TECHNICAL NOTE: 0542018_DDN002

SUBJECT: 50, Hope Street, Wrexham - Separating Floors.

DATE: July 2022.

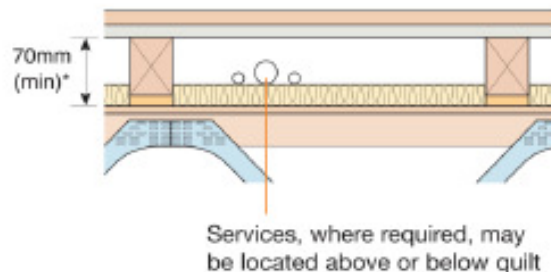
It is understood that existing floors between ground - first floor, and between first - second floor will be removed and replaced. The proposed replacement floors will comprise the following build up:

The proposed new-build timber separating floors are sufficient to meet the sound insulation performance requirements outlined in Table 1. In terms of value engineering, the following amendments could be made without compromising the suitability of the system:

- The Gypsum-based board below the 18mm tongue and groove flooring board on top of the floating timber floor battens can be amended from 15mm Gyproc Soundbloc Board to 12.5mm wallboard throughout.
- The ceiling to the ground floor retail units and first floor apartments could be substituted from 2 x 15mm Gyproc Soundblock Board to 2 x 12.5mm Gyproc Wallboard.

Flanking Strip (Yelofon FS or similar)
used to separate floating floor from
the surrounding structure

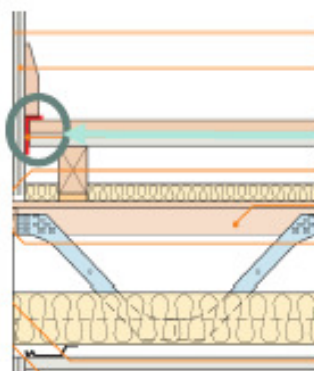
It is important that a flanking strip is included to isolate the floating floor from the surrounding structure, as indicated below. The skirting board should sit on-top of the folded flanking strip as identified in the figure.
